**ADDENDUM NO. 01 – PORTAGE PUBLIC SCHOOLS – HAVERHILL ELEMENTARY SCHOOL BP 6:
CONSTRUCTION**

ADDENDUM NO. 1 (BP 6)

DATE OF ISSUANCE:	July 26, 2023
PROJECT:	Haverhill Elementary School Bid Package 6: Construction 6633 Haverhill Avenue Portage, MI 49024
OWNER:	Portage Public Schools
ARCHITECT'S PROJECT NO.:	21-237.20
ORIGINAL BID ISSUE DATE:	June 30, 2023

SHEET NUMBER
E 201A
DATE
JUNE 30, 2023
21-237.20

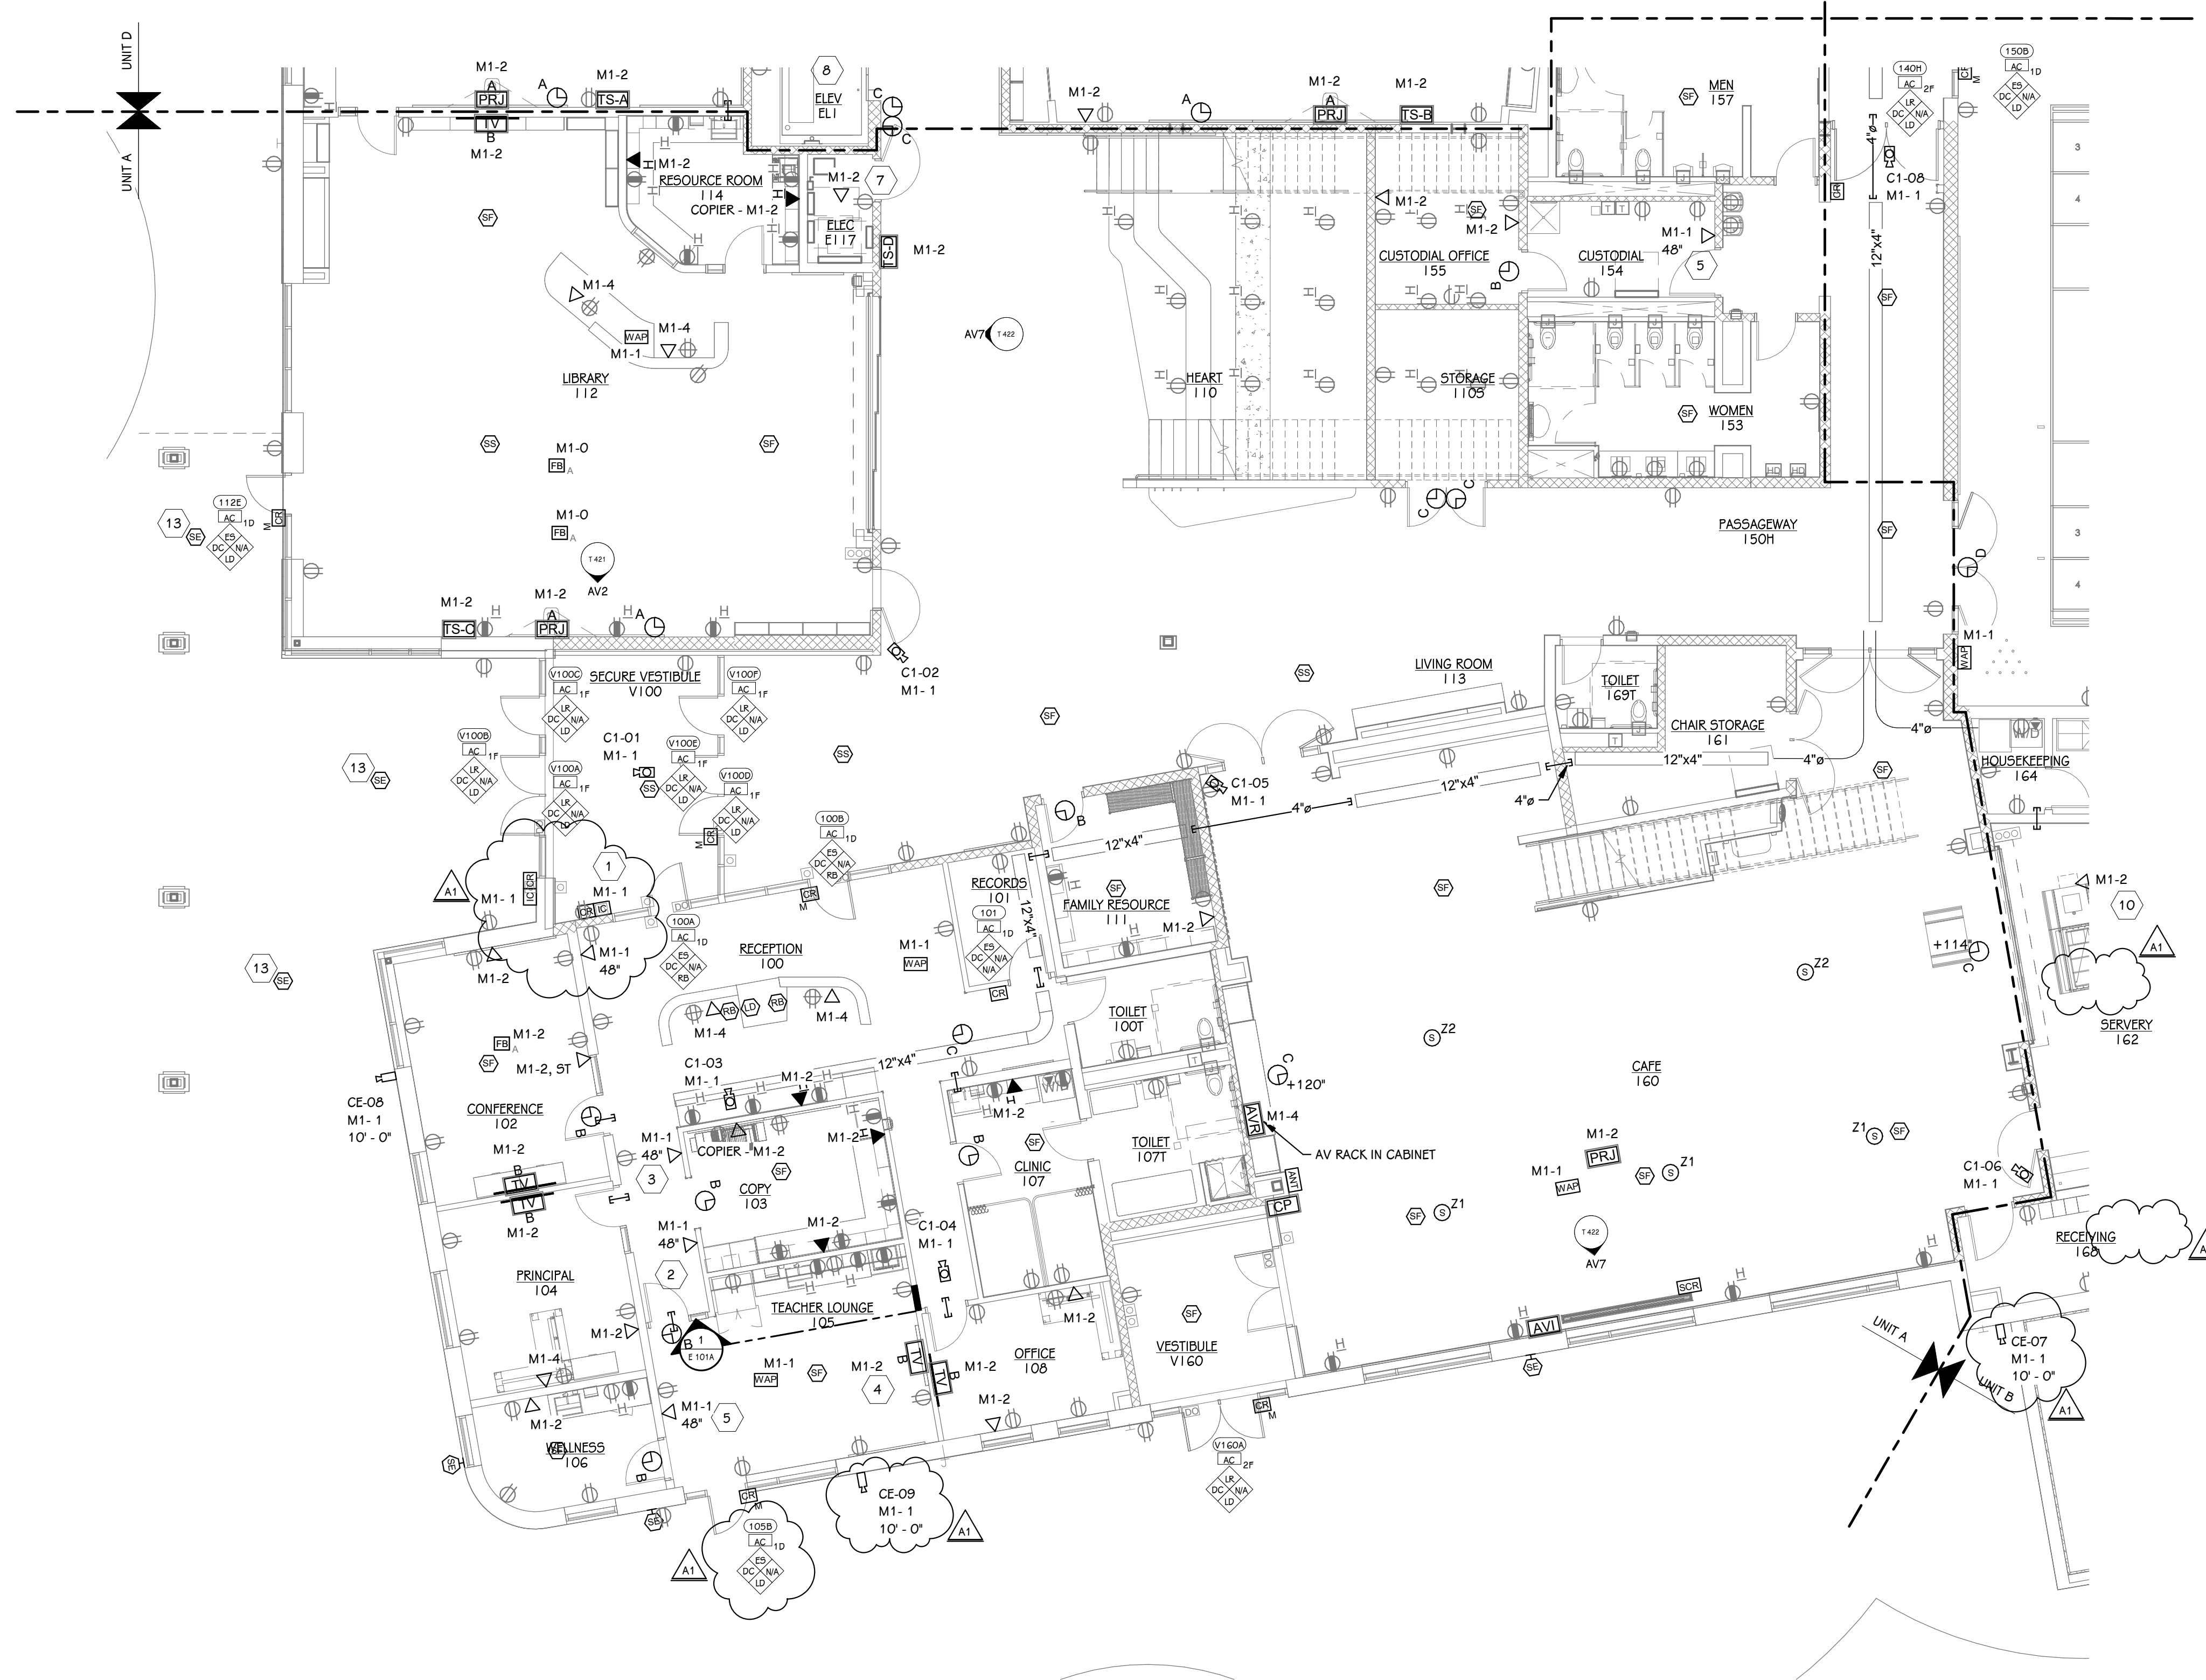
Added EM light to Custodial Room 154
